Appln. No. 10/537,111

Amdt. Dated June 25, 2008

Reply to Non-Final Office Action dated Feb. 26, 2008

Fig. 1a

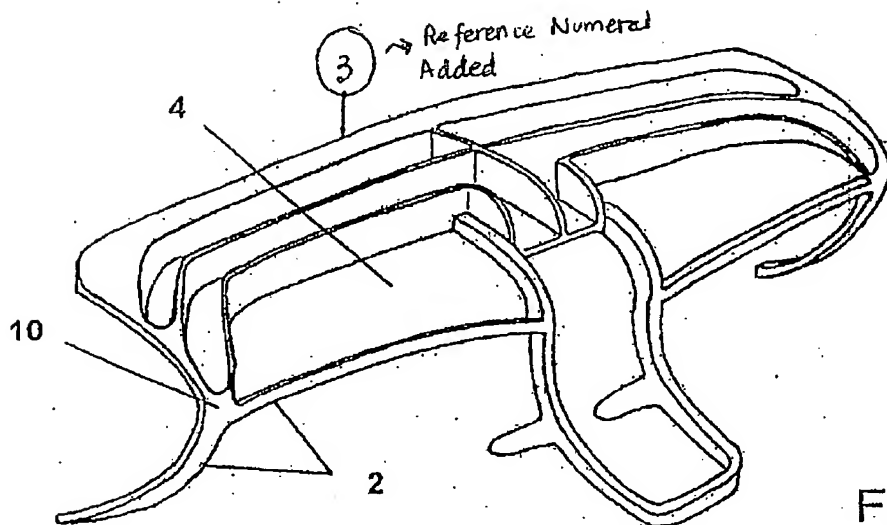
The Examiner has objected to the drawings because of some informalities. (See 2/26/08 Office Action, p. 2). Specifically, the Examiner states that Fig. 1a requires reference numeral 3 to be added; the term "EBENE" from Fig. 1b should be amended to "cut-plane"; and the term "Schnitt B-B" from Fig. 2d should be amended to "cut-line." Figs. 1a, 1b, and 2d have been amended according to the Examiner's suggestions.

The first of the attached sheets of drawings includes changes to Figs. 1a-b. This, sheet which includes Figs. 1a-b, replaces the original sheet including Figs. 1a-b. In Fig. 1a, reference numeral 3 has been added. In Fig. 1b, the term "EBENE" has been replaced with "cut plane," reference numeral 2 has been moved, and an end wall 12 has been added. An annotated sheet indicating the above amendments has been provided.

Fig. 1b

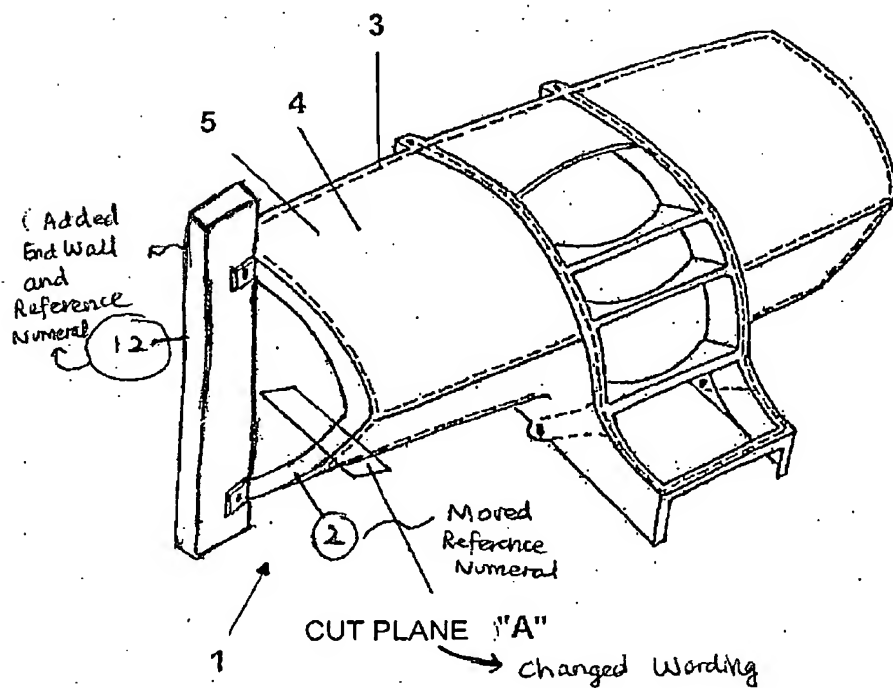
The Examiner has objected to the drawings under 37 CFR 1.83(a) for not showing every feature of the invention specified in the claims. (See 2/26/08 Office Action, p. 2). Specifically, the Examiner states that the figures must show "at least one of an end wall of the vehicle and a body of the vehicle," as recited in claim 24. Fig. 1b has been amended to show this feature by added an end wall 12. The Specification has been amended to address this new reference numeral. Specifically, paragraph [0043] has been amended to include the new reference numeral 12.
